Wisconsin Department of Transportation

Proposal #09: 5992-11-31/32/33, WISC 2022233
City of Madison, University Avenue
Shorewood Blvd to University Bay Drive
Local Street
Dane County

This is Addendum No. 02, which provides for the following:

ADDENDUM NO. 02
PROJECT ID 5992-11-31/32/33
March 3, 2022

Addendum No. 02
 ID 5992-11-31
 Revised Sheet 166
 March 3, 2022

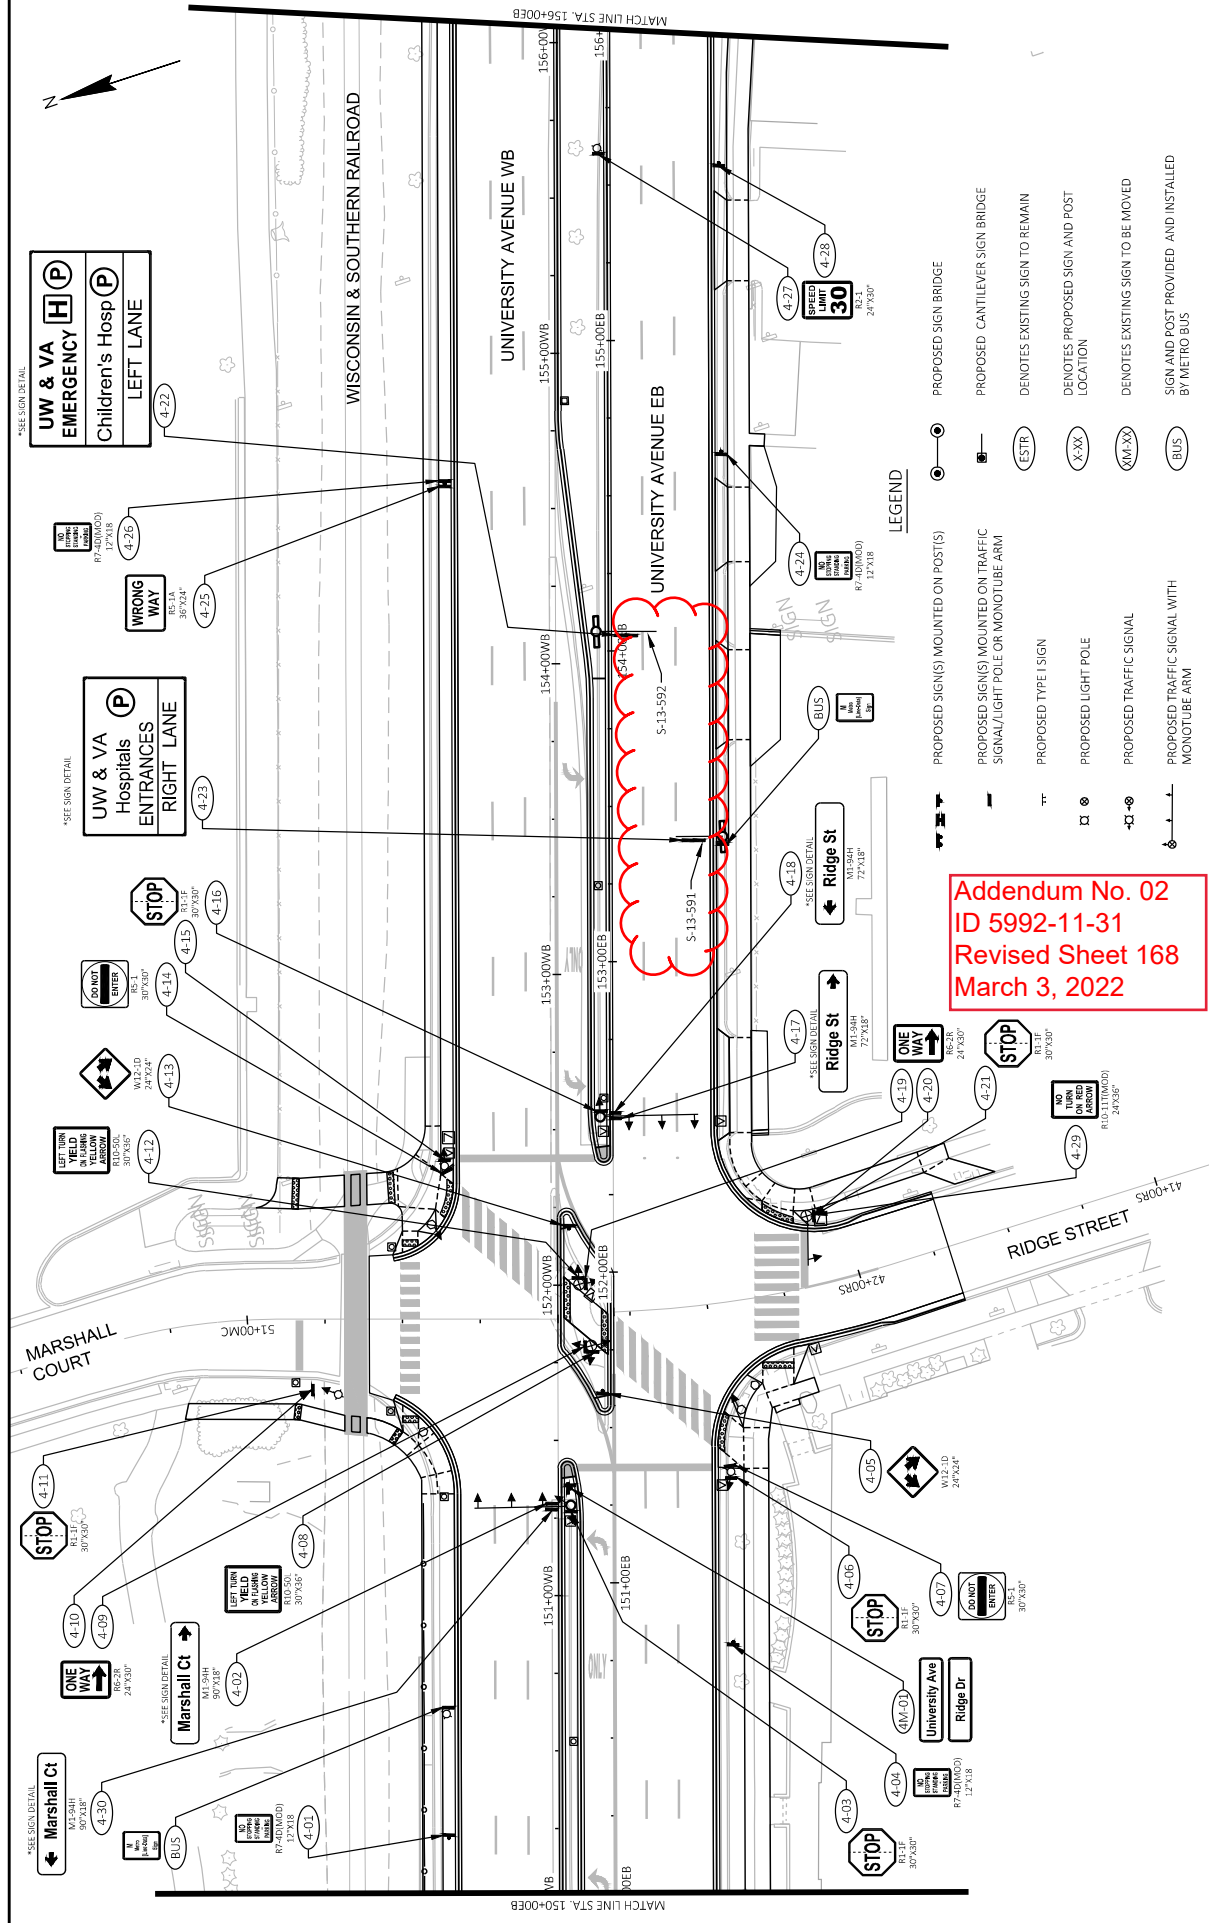
Revised Plan Sheets	
Plan Sheet	Plan Sheet Title (brief description of changes to sheet)
3	Project Overview. Add sign structures
166, 168-169	Permanent Signing. Add sign structure label
351	Remove Monotube Cantilever Table. Quantity now included on sign structure plans.
379, 383	Plan and Profile. Detail. Add sign structure label

Addendum No. 02
ID 5992-11-31
Added Sheet 632B
March 3, 2022

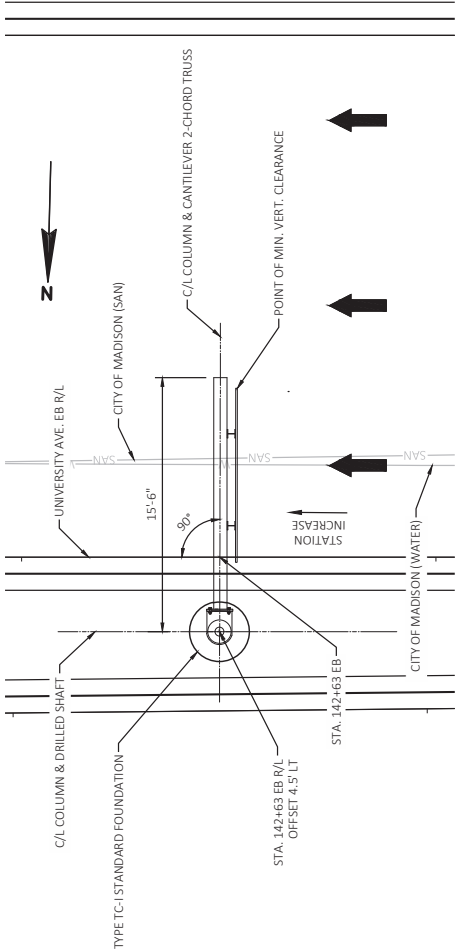
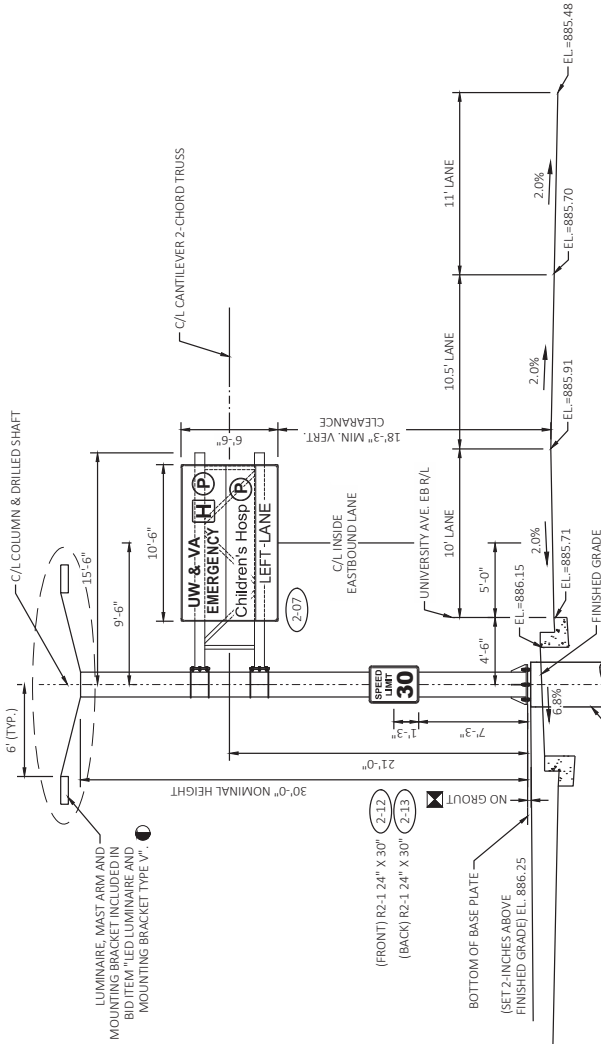
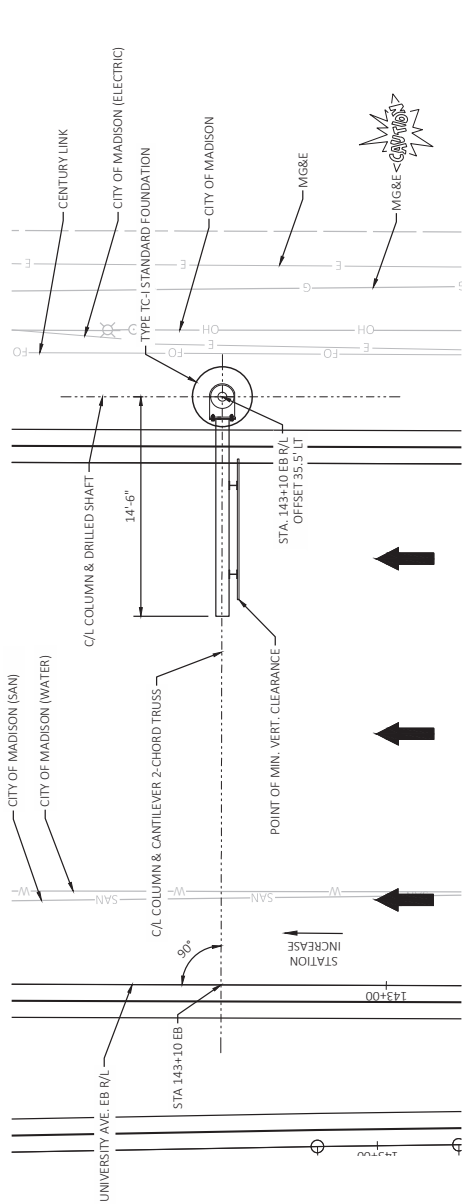
Added Plan Sheets	
Plan Sheet	Plan Sheet Title (brief description of why sheet was added)
632A-632J	Sign Structure Plans S-13-589/590/591/592/593
